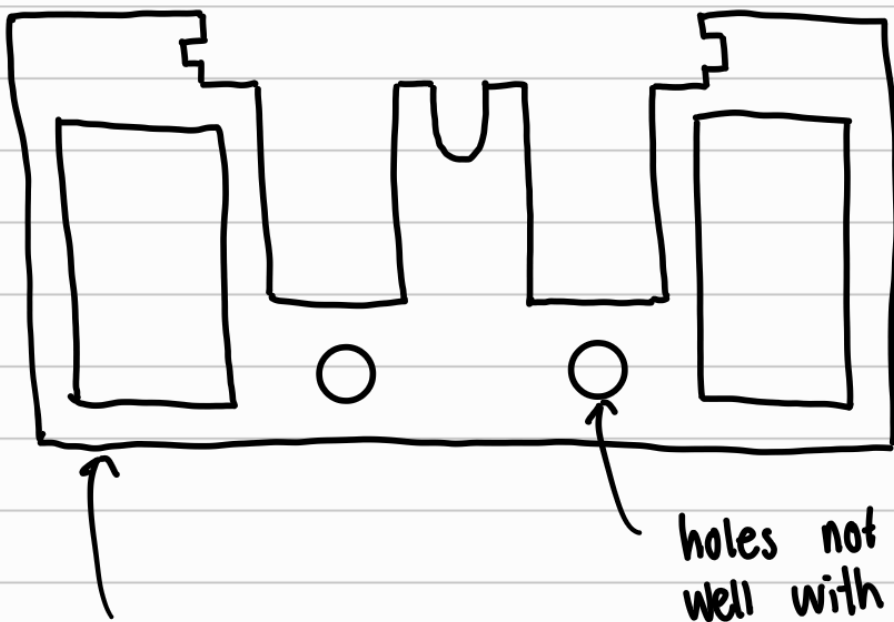
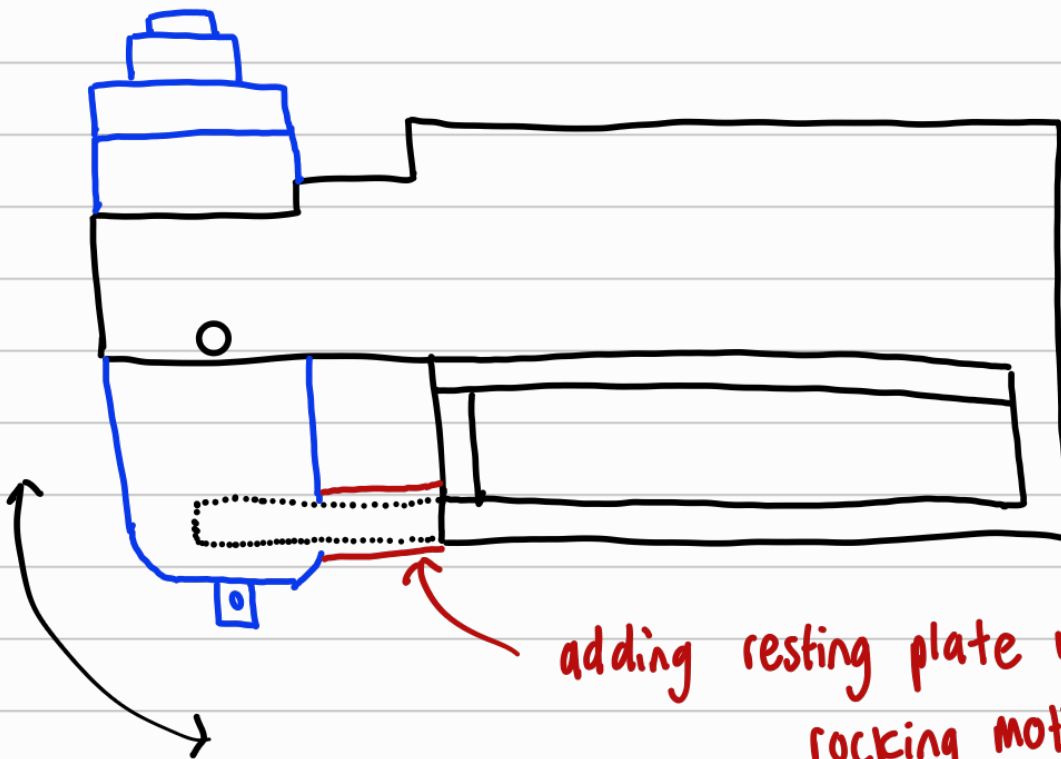
↓ Arduino gap should increase by 1-2 mm

Revise this structure for more strength

holes not aligned well with battery holder

adding resting plate will remove rocking motion

DC motor is locked in but rocks back and forth

- encoder does not lie completely flat, the soldering increases width by 1-2 mm.
- slot design and battery holder are perfect friction fits.
- encoder wheel is loose on the motor shaft.
